Technical Service Bulletin

SUBJECT:		No: TSB-19-34-004	
ABNORMAL NOISE FROM REAR SHOCK ABSORBER		DATE: October 2019	
		MODEL: 2014-16 Outlander	
CIRCULATE TO:	<input type="checkbox"/> GENERAL MANAGER	<input checked="" type="checkbox"/> PARTS MANAGER	<input checked="" type="checkbox"/> TECHNICIAN
<input checked="" type="checkbox"/> SERVICE ADVISOR	<input checked="" type="checkbox"/> SERVICE MANAGER	<input checked="" type="checkbox"/> WARRANTY PROCESSOR	<input type="checkbox"/> SALES MANAGER

TIP 1: LH Side Disassembly

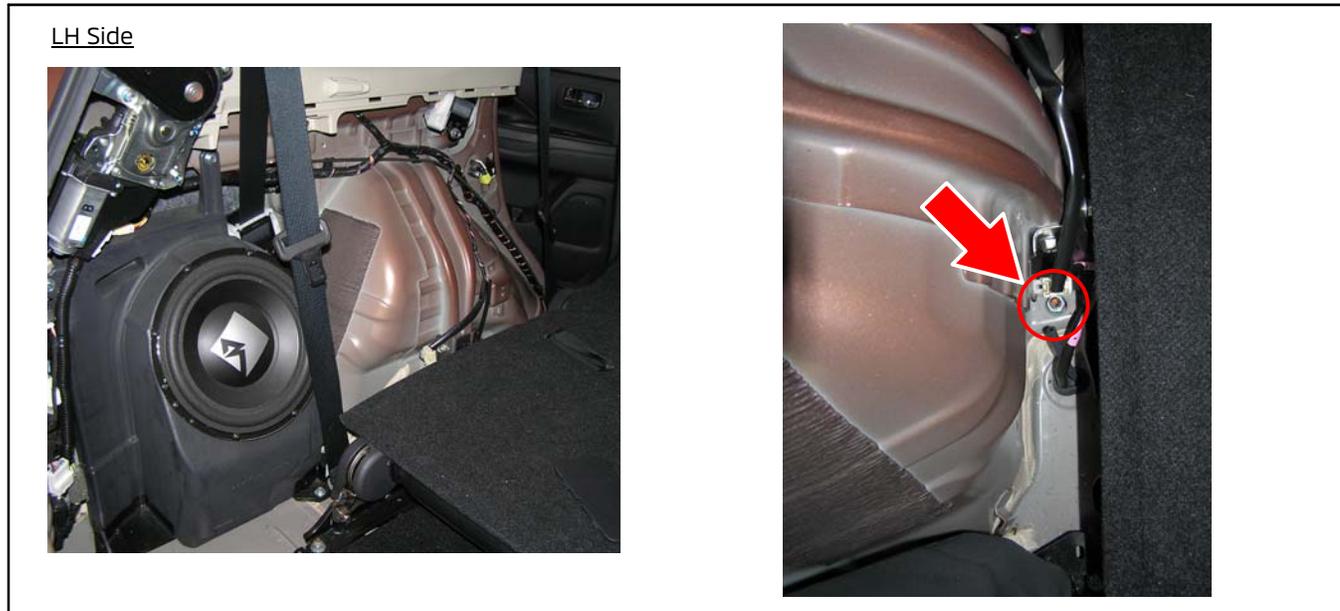
1. In order to access the upper bolts of the LH shock absorber assembly, some interior panels must be removed, as shown.

NOTE: There are two LH upper bolts. Rear LH bolt shown in photo below for example of access.

TIP 2: RH Side Disassembly

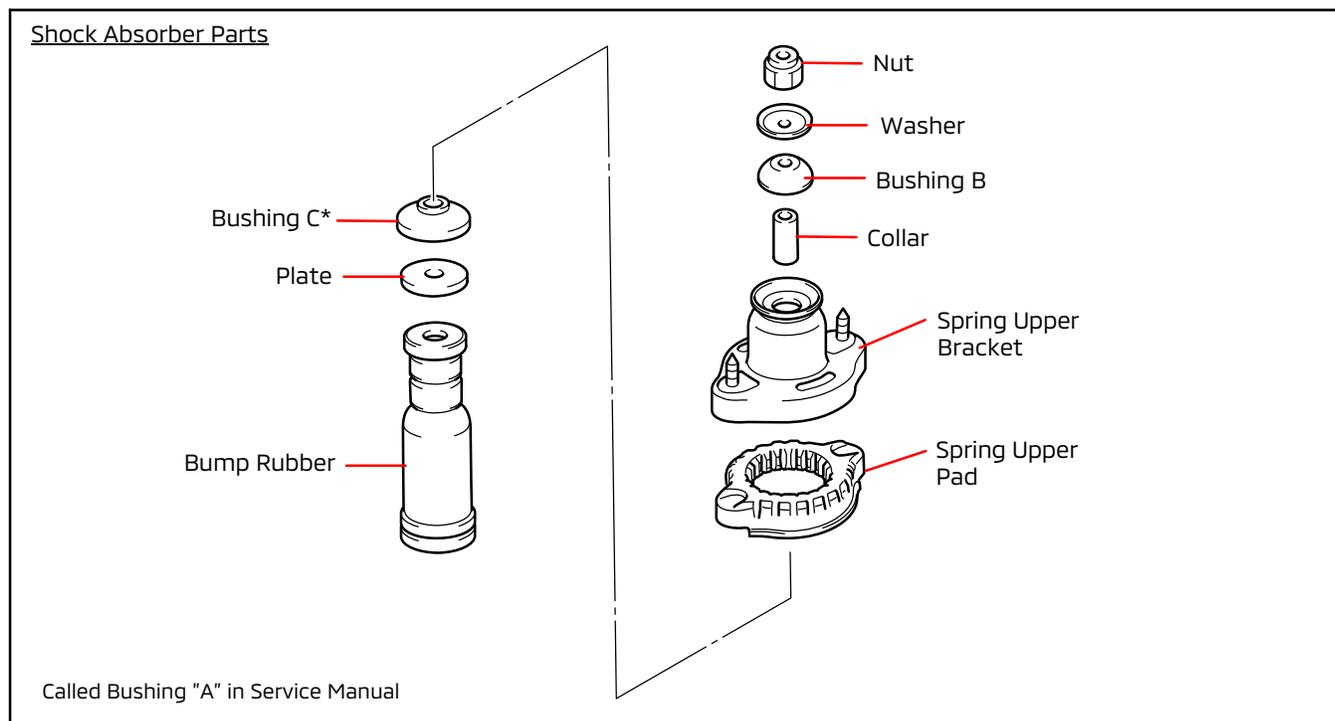
2. In order to access the upper bolts of the RH shock absorber assembly, only the cup holder panel must be removed, as shown.

NOTE: There are two RH upper bolts. Rear RH bolt shown in photo below for example of access.
